ADDENDUM NO. 3

SR 169 Widening Phase 1 Roadway Improvements
Witte Road SE to SE 240th Street
City Project T-39
TIB Project 8-1-205(005)-1

Date: February 15, 2019
To: All Plan and Specification Holders
From: Scott Soiseth, P.E.
Subject: SR 169 Widening Phase 1 Roadway Improvements
Date of Bid Opening: February 19, 2019

SG02
 SHEET 71 OF 103 SHEETS

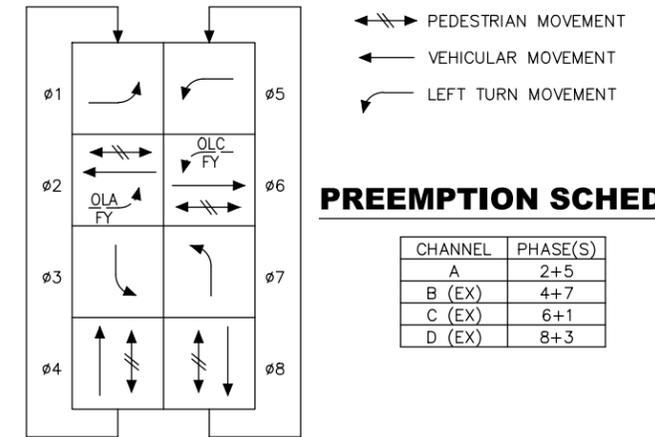
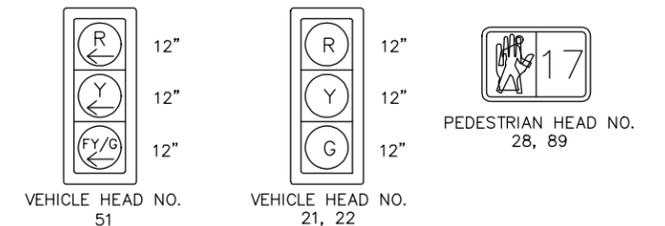
- 1) Sheets 71 and 73 –Traffic Signal Plan and Traffic Signal Notes: Replacement of sheets to show updated Signal Display Note 5 (on SG02) and updated Construction Pole Notes 4 & 8 (on SG04) to reflect that relocated pedestrian signal heads on new PS poles shall be installed on new Type D mounts.
